SHOP DRAWING REVIEW

2 RAIL BRIDGE RAIL TO GUARDRAIL TRANSITION

ROCHESTER, BR# 0162 (17) VT RTE 73 (MAJOR COLLECTOR), BRIDGE NO: 16, OVER CORPORATION BROOK TOWN OF ROCHESTER, COUNTY OF WINDSOR, VT

DETAIL SHOWING PIE CUT LOCATIONS @ WW 2, FOR 8'-6" CONVEX RAD. ON FACE OF RAIL.

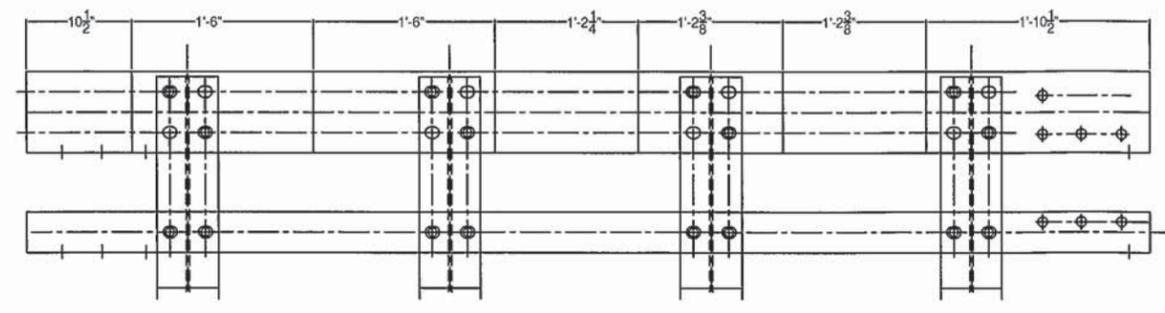
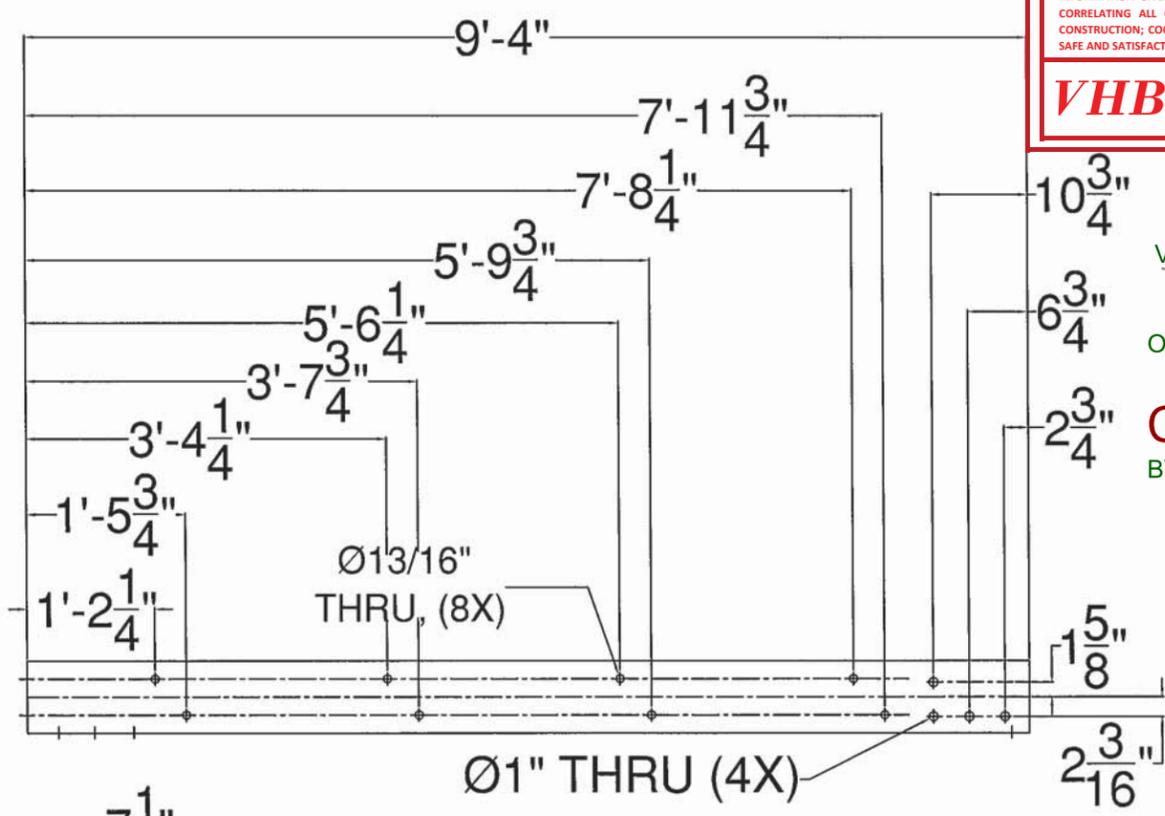
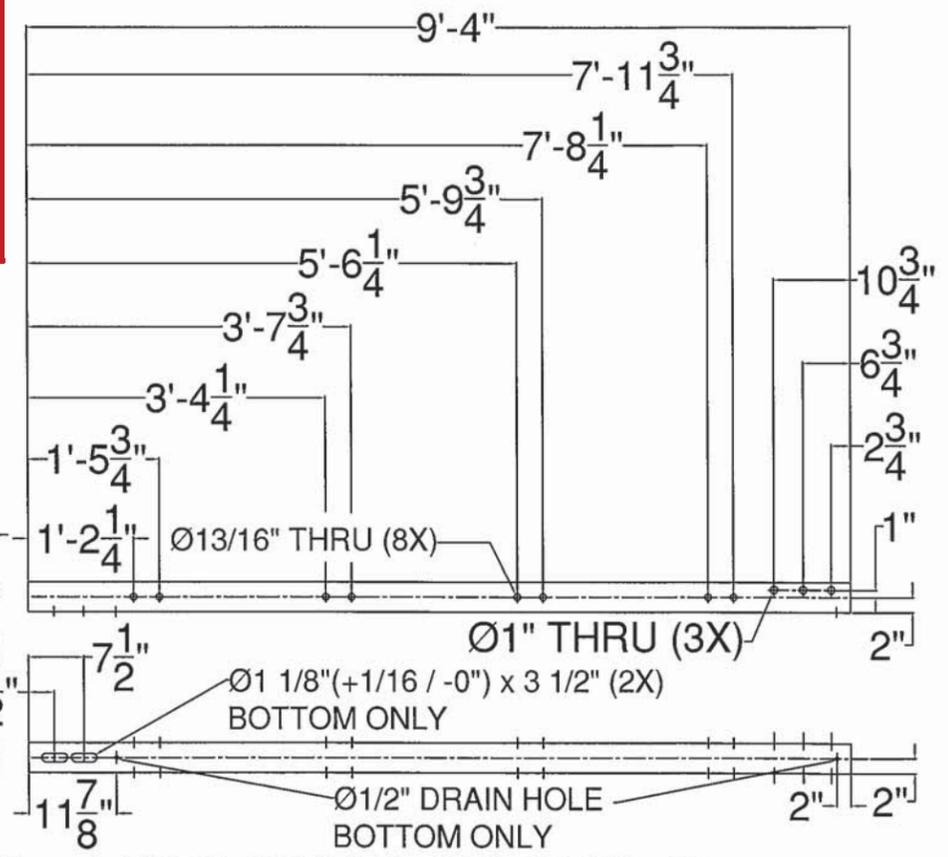
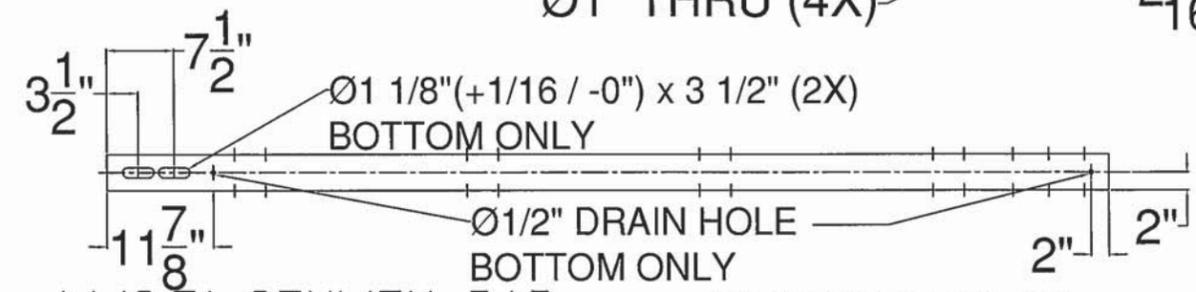
WW 2 - W/8.5' CONVEX RAD. ADD PRESS FIT END CAP— THIS END ONLY
 WW 3

WW 2 - W/8.5' CONVEX RAD, ADD PRESS FIT END CAP— THIS END ONLY
 WW 3
